PROJECT  
LIVERPOOL HEALTH & ACADEMIC PRECINCT  
ELIZABETH STREET LIVERPOOL, NSW  
CLIENT  
HEALTH INFRASTRUCTURE  
14/77 PACIFIC HWY, NORTH SYDNEY NSW 2060

STATUS  
SSDA AMENDMENT

Approved Section: 4.55(1A)    Application: 55D-10388-Mod-1

PROJECT NO.	DRAWING NO.	ISSUE
21807	A-SSDA-MSCP-28	08
STATUS		
SSDA AMENDMENT

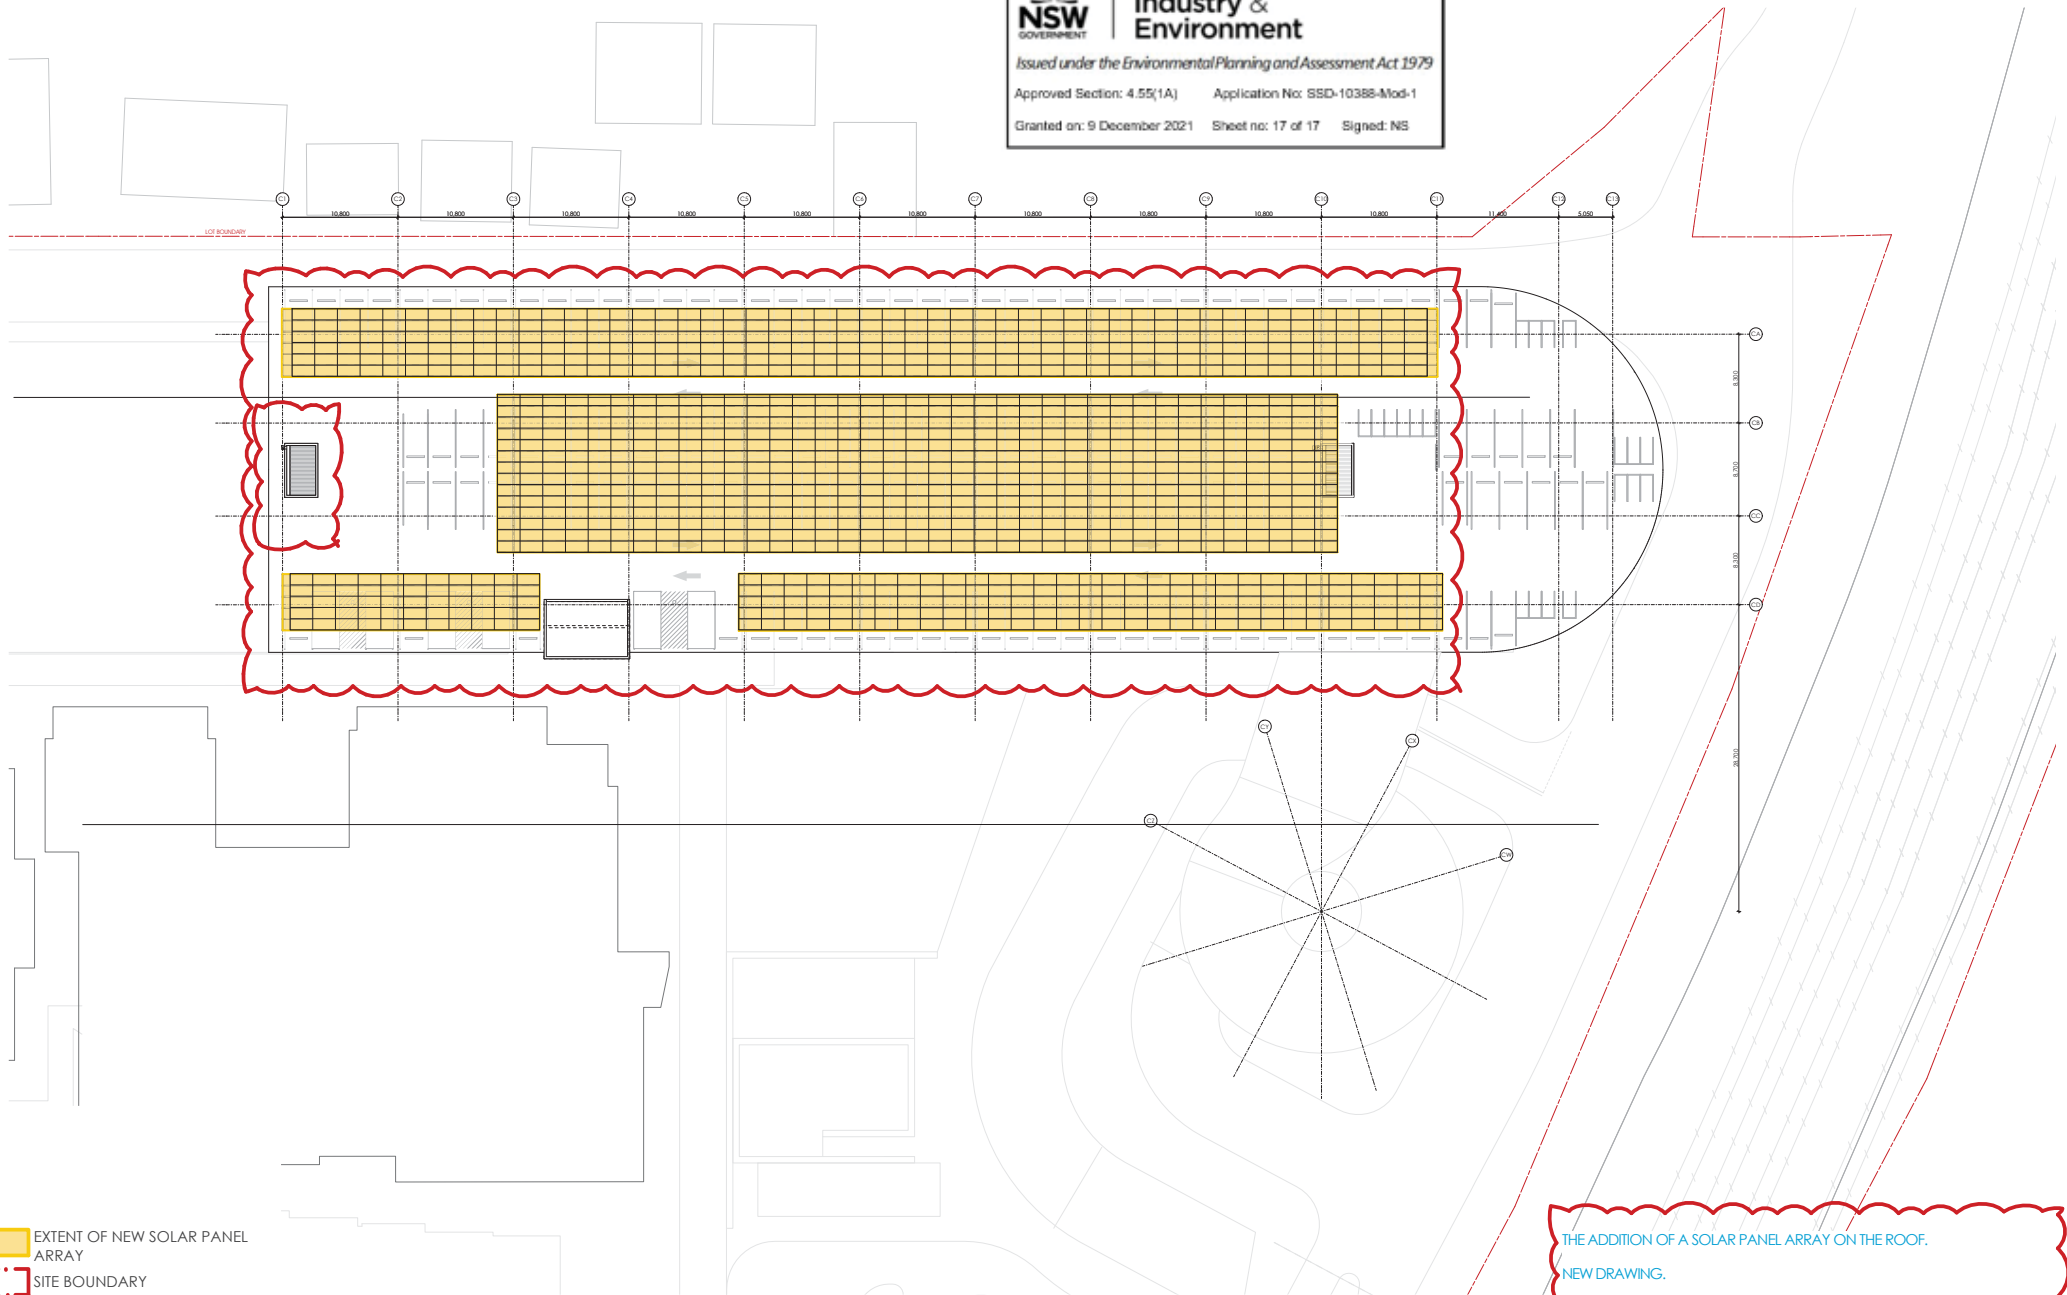
THE ADDITION OF A SOLAR PANEL ARRAY ON THE ROOF.  
 NEW DRAWING.  
 FIRE STAIR (EAST) GRID C10/CC ON ALL LEVELS RECONFIGURED ON ALL LEVELS
